RECOMMENDED SERVICE BULLETIN

RSB 42-139

RSB 42NG-081

Replacement of rudder T-yoke axle with improved design.

6.	 <p>picture 1</p>	 <p>picture 2</p>
	 <p>picture 3</p>	 <p>picture 4</p>

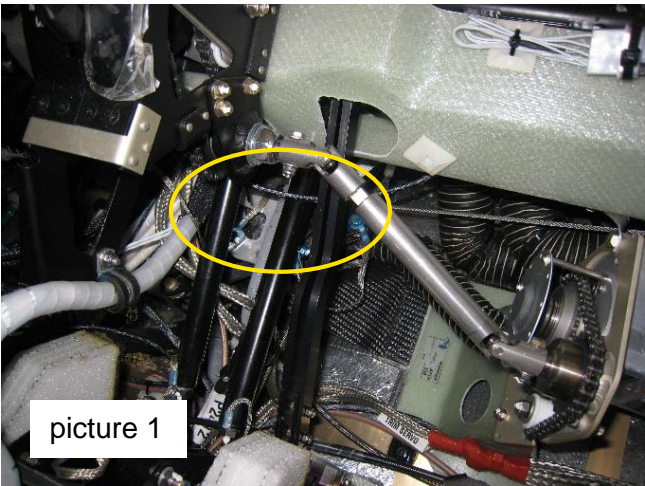
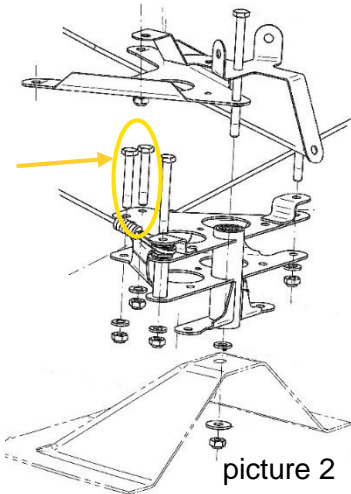
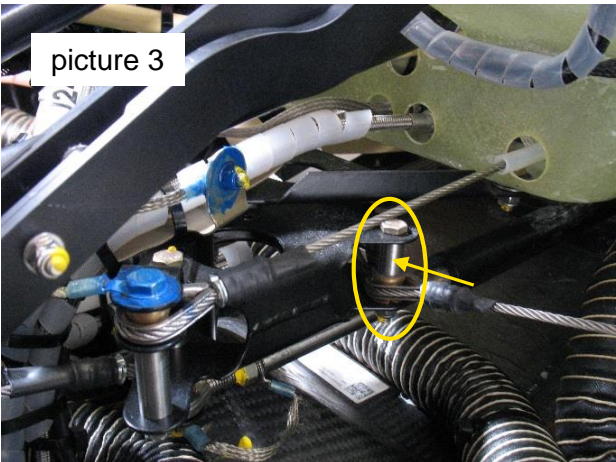
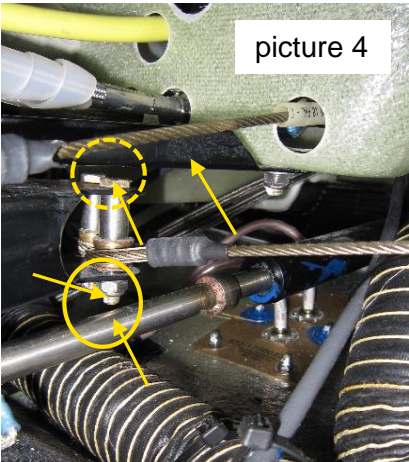
- between end of T-yoke bolts for copilot's right rudder cable & pilot's left rudder cable and nose landing gear (NLG) steering rod (continuous circle in picture 4)
- and between head of T-yoke bolts for copilot's right rudder cable & pilot's left rudder cable and support plate (dashed circle in picture 4).

Record the measured clearances. Each clearance must be greater than 2 mm (0.08 in).

figure 2

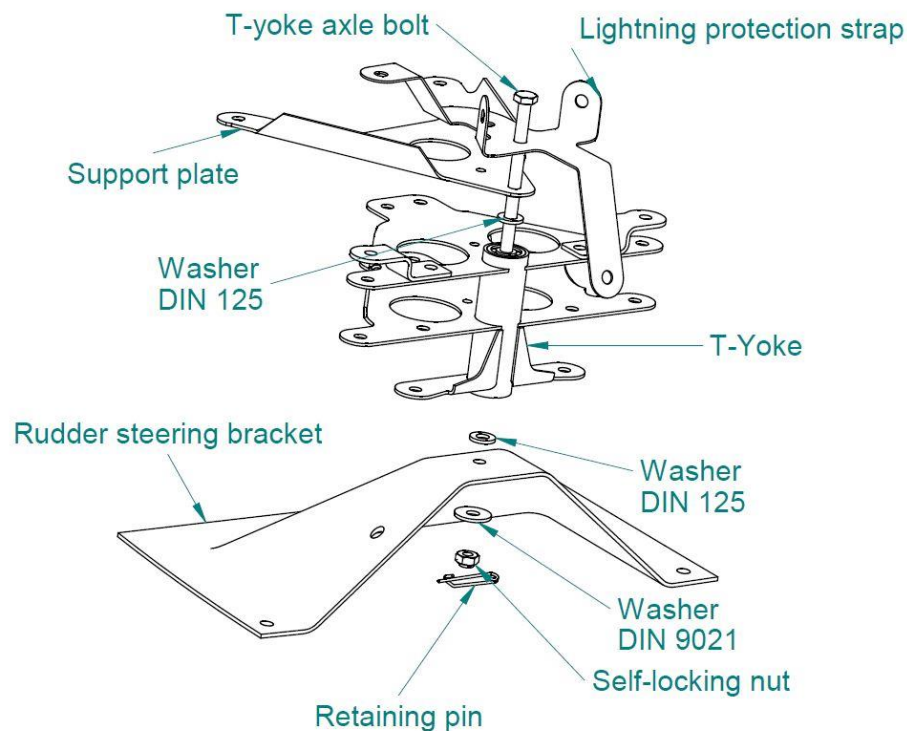
- the new T-yoke bolt D60-5320-00-32,
- a DIN 125 washer between support plate and T-yoke,
- a DIN 125 washer between the T-yoke and the rudder steering bracket,
- a DIN 9021 washer between the self-locking nut and the rudder steering bracket,
- a new self-locking nut and
- a retaining pin AN416-1 perpendicular to the flight direction

Note: The retaining pin can damage the heating hose if not installed perpendicular to the flight direction.

Tighten the T-yoke bolt with a tightening torque of 10 Nm.

figure 3

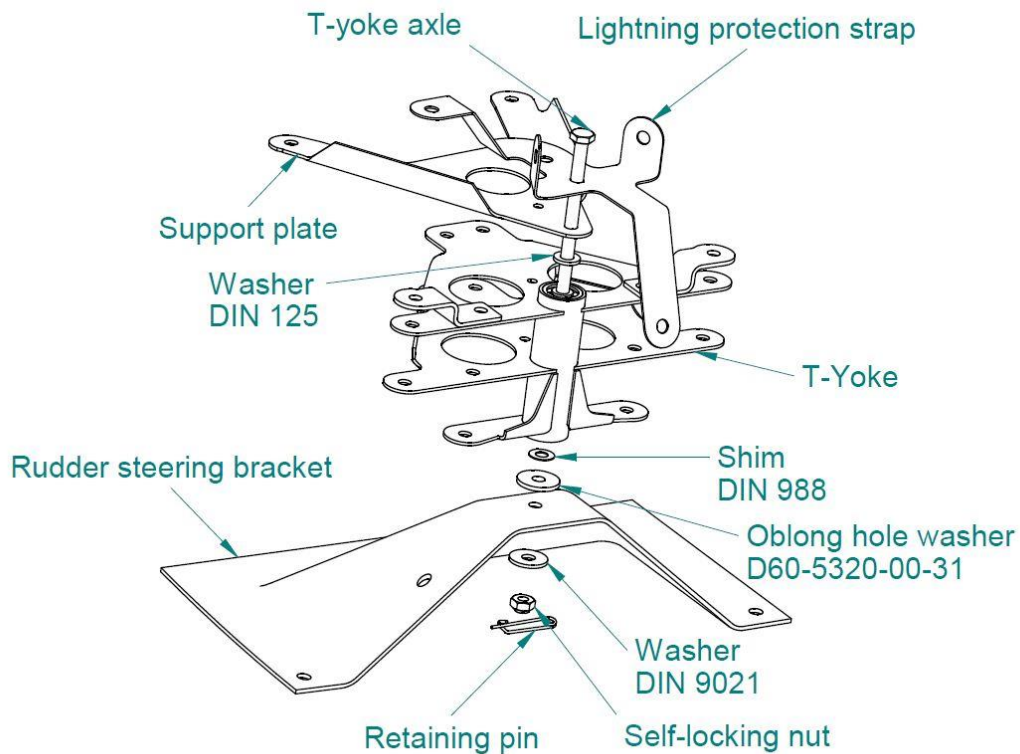
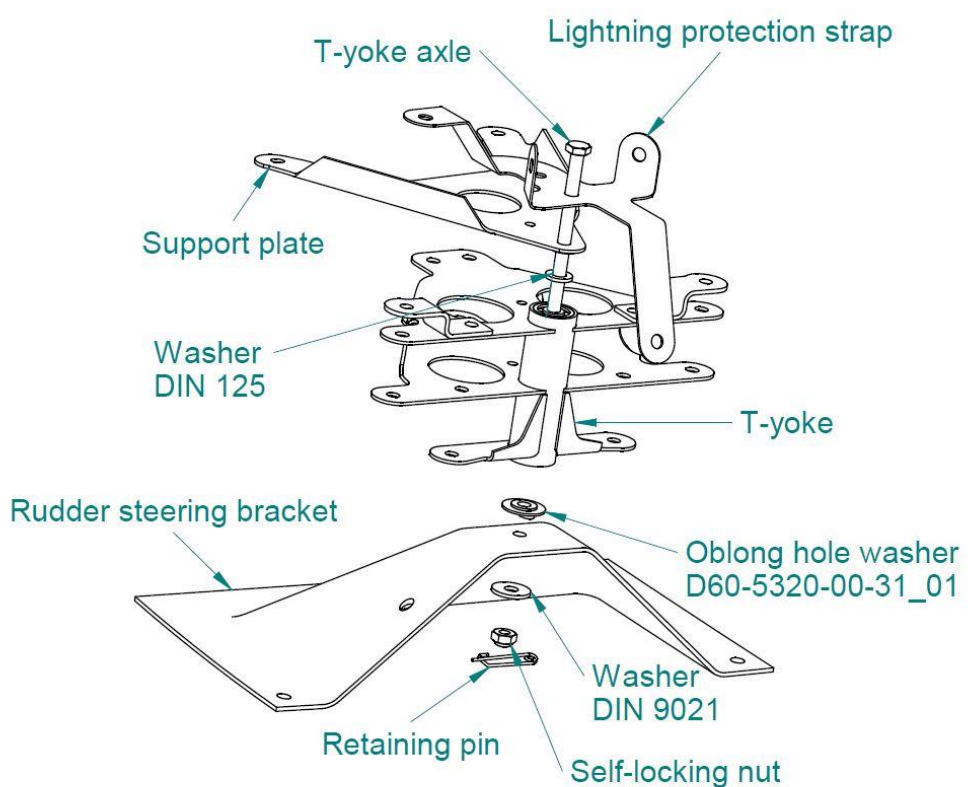
- the new T-yoke bolt D60-5320-00-32,
- a DIN 125 washer between support plate and T-yoke,
- a DIN 988 shim between the T-yoke and well bonded oblong hole washer,
- a DIN 9021 washer between the self-locking nut and the rudder steering bracket,
- a new self-locking nut and
- a retaining pin AN416-1 perpendicular to the flight direction

Note: The retaining pin can damage the heating hose if not installed perpendicular to the flight direction.

| 2. | Tighten the T-yoke bolt with a tightening torque of 10 Nm. |
